APPLICATION FOR PERMISSION  
UNDER SECTION 16 OF  
THE TOWN PLANNING ORDINANCE  
(CAP. 131)

For Official Use Only 請勿填寫此欄	Application No. 申請編號	A/76-KTS/1011
	Date Received 收到日期	17 JUL 2024

(a) Proposed use(s)/development 擬議用途/發展	Temporary Place of Recreation, Sports or Culture (Hobby Farm and Fishing Ground), Barbecue Site and Education Centre with Ancillary Eating Place for a Period of 3 Years and Associated Filling of Land  (Please illustrate the details of the proposal on a layout plan) (請用平面圖說明擬議詳情)

**(S.16 Planning Application No. A/YL-KTS/1011)**

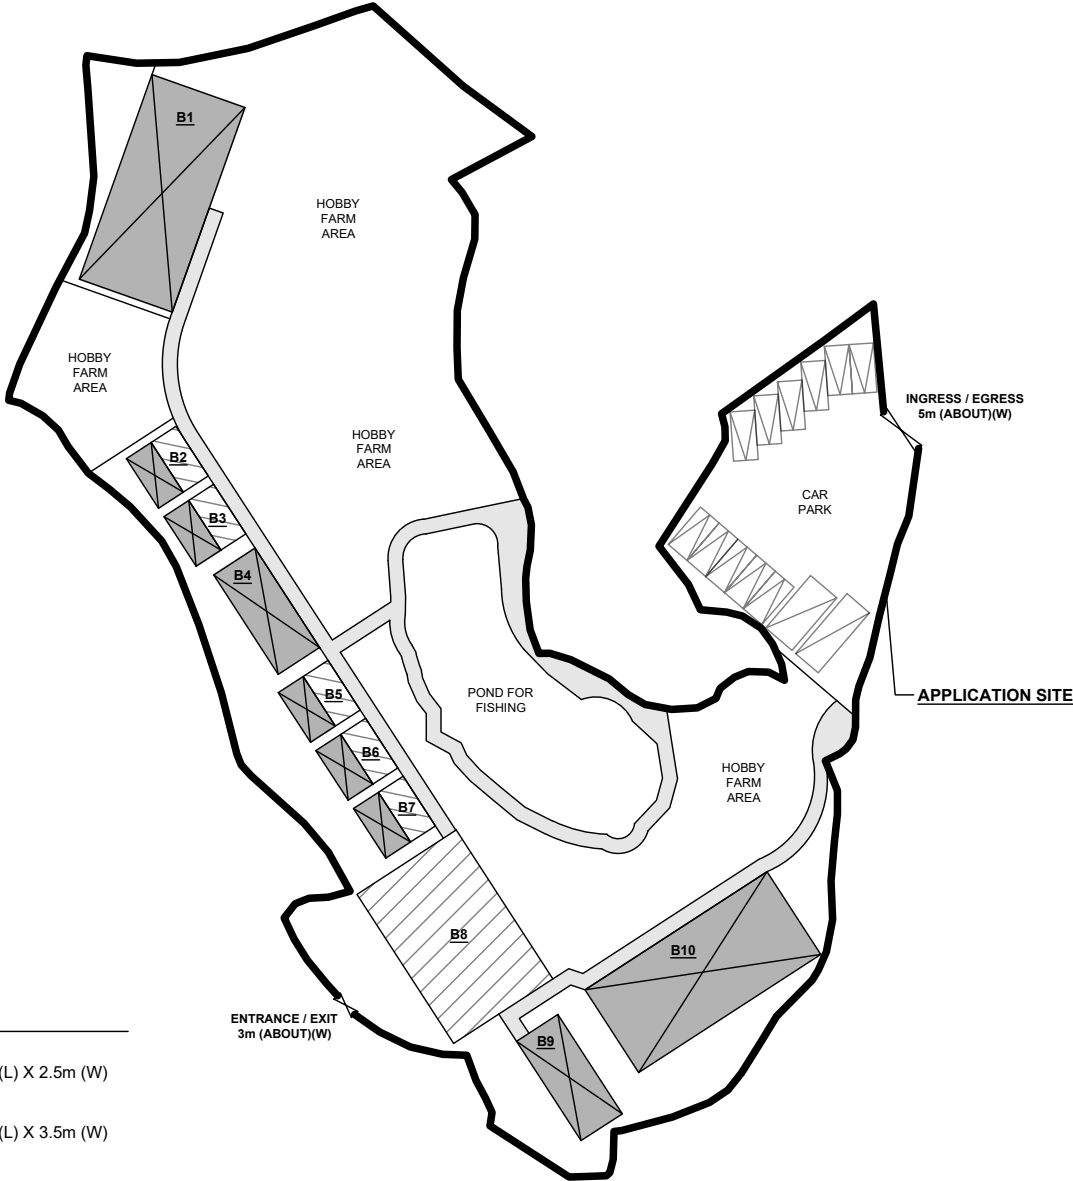
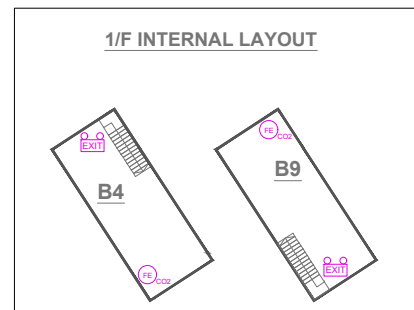
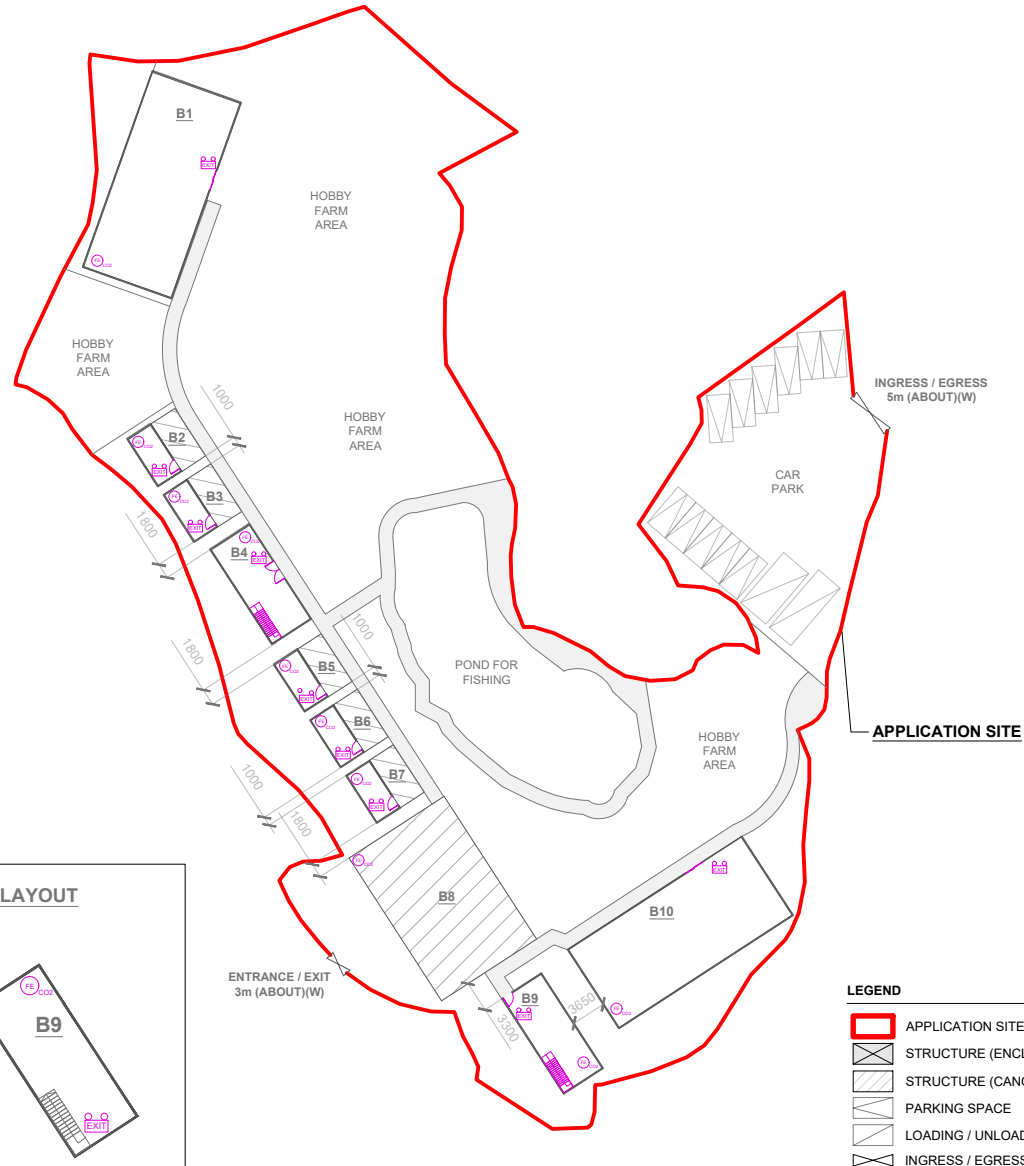
2. Comments of Director of Fire Services (D of FS) (Contact Person: Mr. YUEN; Tel: 2733 7781)		
(a)	The standards and specification of the proposed emergency lighting shall be revised to 'BS 5266-1:2016, BS EN 1838:2013 and the FSD Circular Letter No. 4/2021';	Noted and revised accordingly. Please refer to the revised fire service installations proposal ( <b>Annex I</b> ).

(b)	The total floor area and occupancies of structure B11 shall be clearly stated on plan; and	
(c)	Structures on the same site are regarded as adjoining structures if they are less than 1.8m apart. Additional FSIs (i.e. sprinkler system, modified hose reel system and fire alarm system) shall be provided for Structures B6, B7 & B8 as the total floor areas exceeds 230m <sup>2</sup> .

## FIRE SERVICE INSTALLATIONS

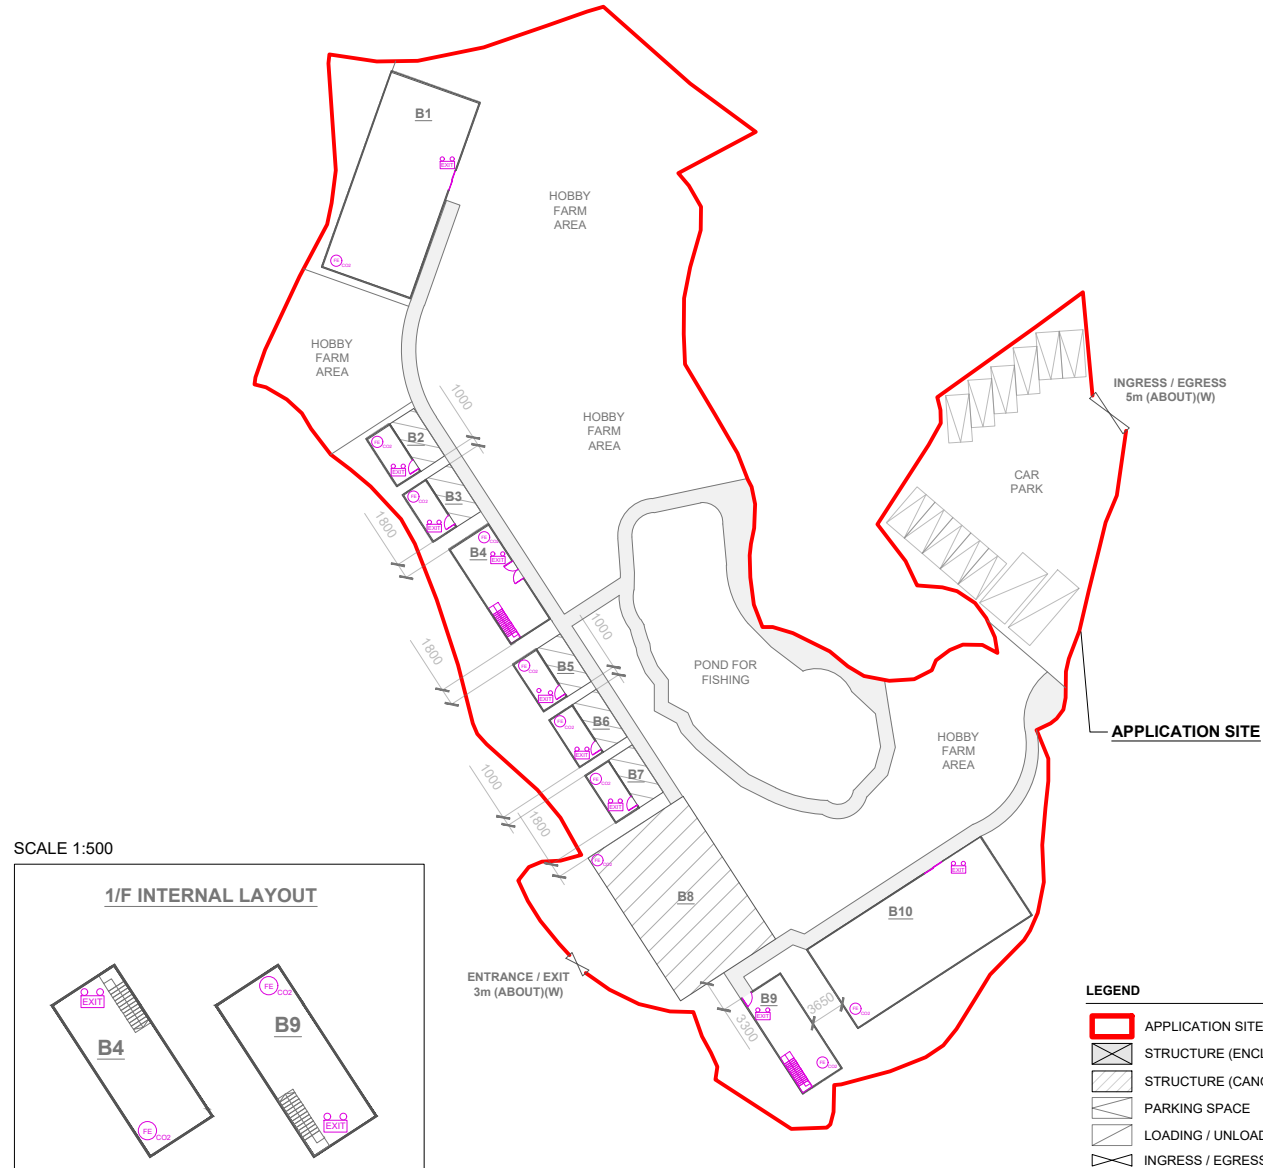
Departmental Comments		Applicant's Responses
<b>1. Comments of Director of Fire Services (D of FS)</b> <b>(Contact Person: Mr. CHEUNG; Tel: 2733 7781)</b>		
(a)	The standards and specification of the proposed emergency lighting shall be revised to “BS 5266-1:2016, BS EN 1838:2013 and the FSD Circular Letter No. 4/2021”.	Noted and revised accordingly. Please refer to the revised fire service installations proposal ( <b>Annex I</b> ).
